ATTACHMENT 4 TO TXX-15101
EMERGENCY ACTION LEVEL
TECHNICAL BASES
(REDLINE AND STRIKEOUT VERSION)
(276 PAGES)

**Comanche Peak Nuclear Power Plant
EPP-201
Emergency Action Level Technical Bases Document**

DRAFT D2 6/24/15

Figure 1: Containment Integrity or Bypass Examples

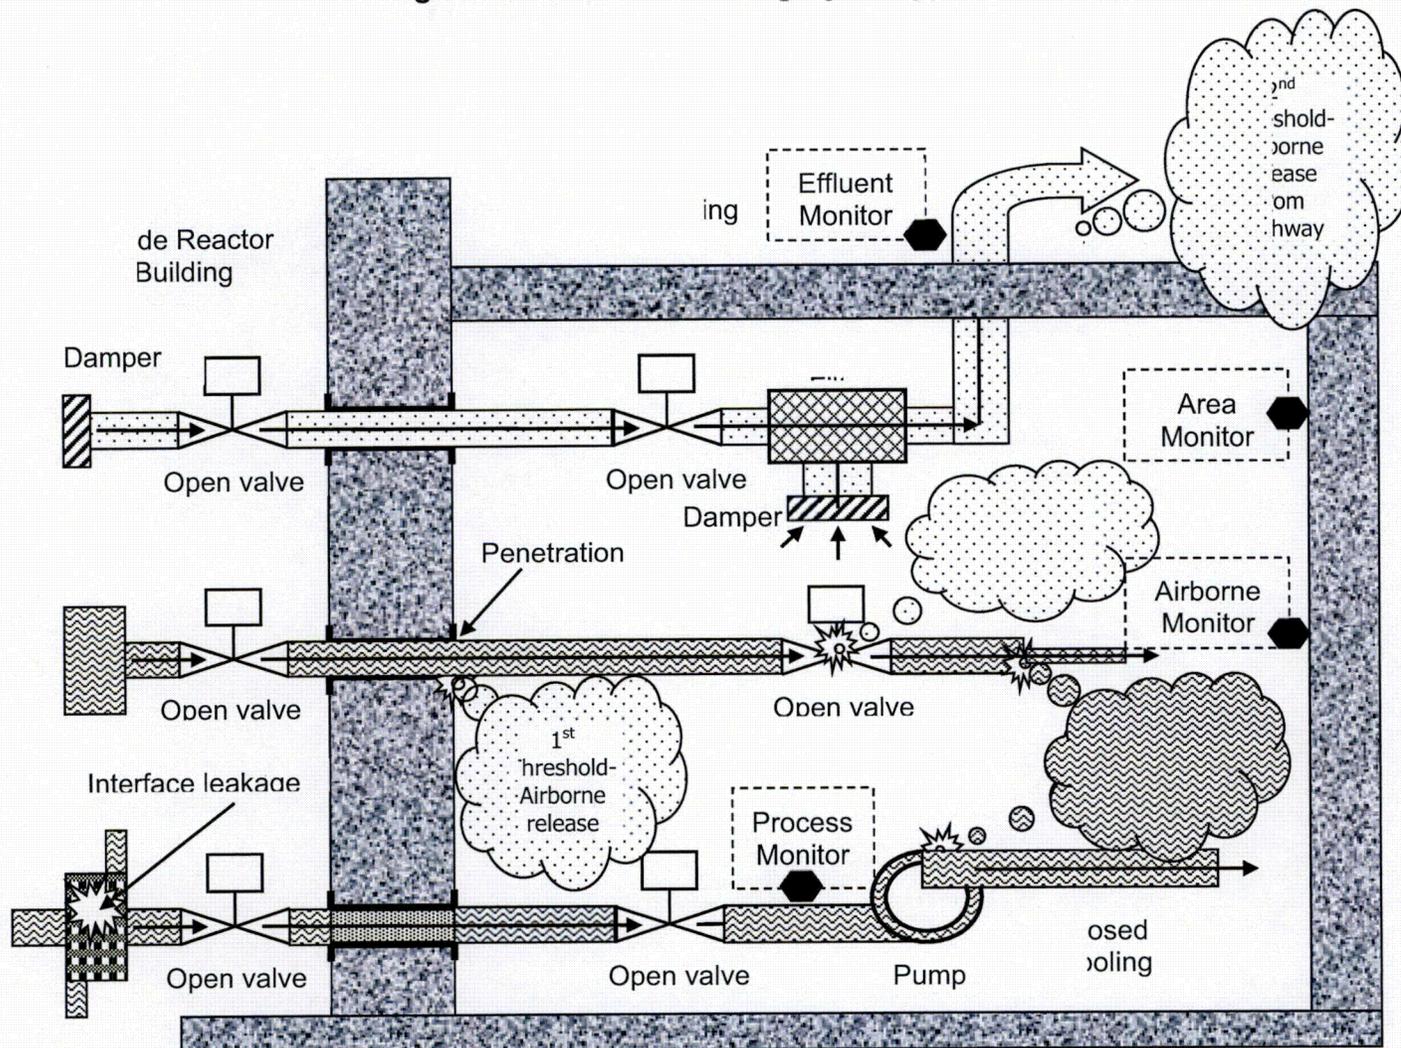
Refer to the top piping run of Figure 9-F-41. In this simplified example, the inboard and outboard isolation valves remained open after a containment isolation was required (i.e., containment isolation was not successful). There is now an UNISOLABLE pathway from the containment to the environment.

Refer to the bottom piping run of Figure 9-F-41. In this simplified example, leakage in an RCP seal cooler is allowing radioactive material to enter the Auxiliary Building. The radioactivity would be detected by the Process Monitor. If there is no leakage from the closed water cooling system to the Auxiliary Building, then no threshold has been met. If the pump developed a leak that allowed steam/water to enter the Auxiliary Building, then second threshold 4.B would be met. Depending upon radiation monitor locations and sensitivities, this leakage could be detected by any of the four monitors depicted in the figure and cause the first threshold 4.A.1 to be met as well.

Refer to the middle piping run of Figure 9-F-41. In this simplified example, a leak has occurred at a reducer on a pipe carrying reactor coolant in the Auxiliary Building. Depending upon radiation monitor locations and sensitivities, the leakage could be detected by any of the four monitors depicted in the figure and cause threshold 4.AD.1 to be met as well.

To ensure proper escalation of the emergency classification, the RCS leakage outside of containment must be related to the mass loss that is causing the RCS Loss and/or Potential Loss threshold 4.A.1 to be met.
